**BEFORE THE NORTH CAROLINA UTILITIES COMMISSION  
DOCKET NO. E-7, SUB 1214**

**In the Matter of:  
Application of Duke Energy Carolinas,  
LLC for Adjustment of Rates and  
Charges Applicable to Electric Service  
in North Carolina**

) **TESTIMONY OF DENNIS**  
) **STEPHENS ON BEHALF OF THE**  
) **NORTH CAROLINA JUSTICE**  
) **CENTER, NORTH CAROLINA**  
) **HOUSING COALITION, NATURAL**  
) **RESOURCES DEFENSE COUNCIL**  
) **AND SOUTHERN ALLIANCE FOR**  
) **CLEAN ENERGY AND THE**  
) **NORTH CAROLINA**  
) **SUSTAINABLE ENERGY**  
) **ASSOCIATION**

**February 18, 2020**

1 *Figure 1: Relationship between Grid Investment and Reliability for DEC*

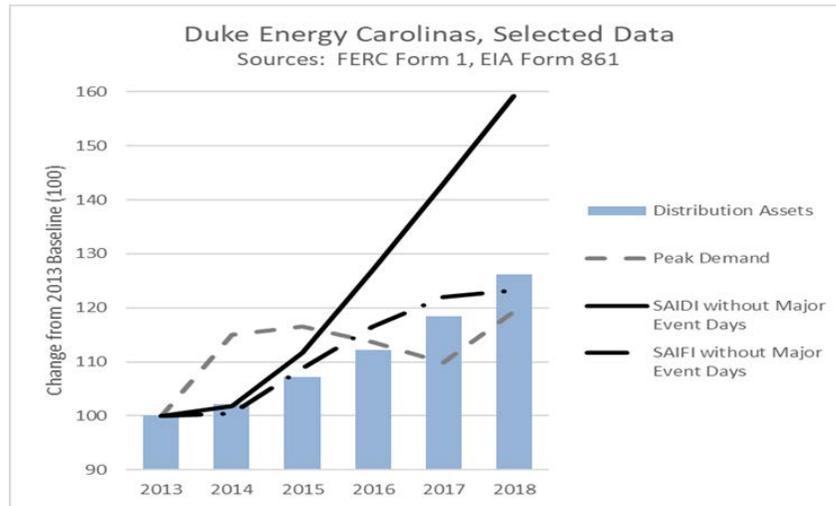
11 A. I completed the same reliability vs. investment analyses for DEC (Figure 1) and  
12 DEP (Figure 2) that Witness Alvarez completed on a national basis, which is  
13 contained in his testimony that is being filed in this docket concurrently.<sup>7</sup> While  
14 growth in peak demand does justify much of DEC’s and DEP’s grid investment  
15 increases, DEC and DEP’s respective grid investment increases exceed peak  
16 demand growth by 37% and 61%<sup>8</sup>. One would hope these excess investments  
17 would lead to at least some reliability improvements. Yet, as is the case  
18 nationally, DEC and DEP’s performance under key indices of reliability, SAIDI  
19 and SAIFI, have deteriorated significantly despite grid investment in excess of  
20 capacity needs. (Note that for SAIDI and SAIFI, lower values represent better  
21 performance.)

5 As shown in Figure 1, DEC’s SAIDI and SAIFI performance have  
 6 deteriorated almost 60% and more than 20%, respectively, since 2013 despite grid  
 7 investment growth 37% greater than peak demand growth. As shown in Figure 2,  
 8 DEP’s SAIDI and SAIFI performance have deteriorated almost 50% and more

3 *Figure 2: Relationship between Grid Investment and Reliability for DEP<sup>9</sup>*

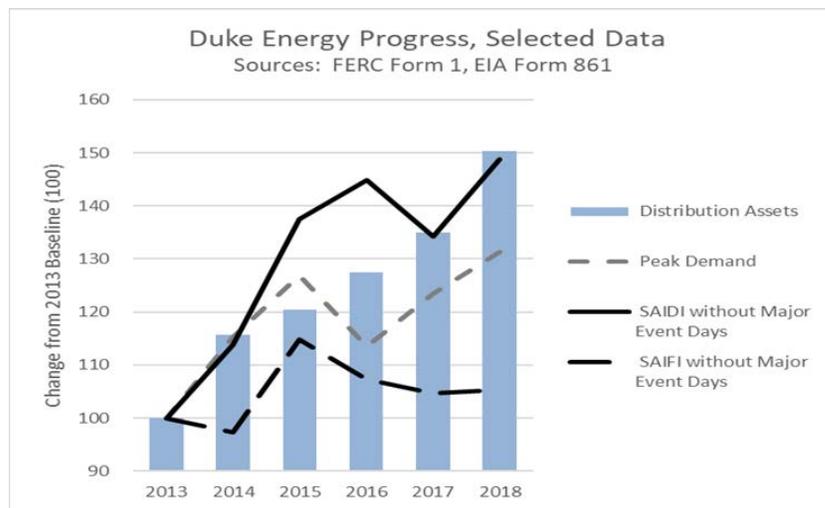
1 than 5%, respectively, since 2013 despite grid investment growth 61% greater  
2 than peak demand growth.
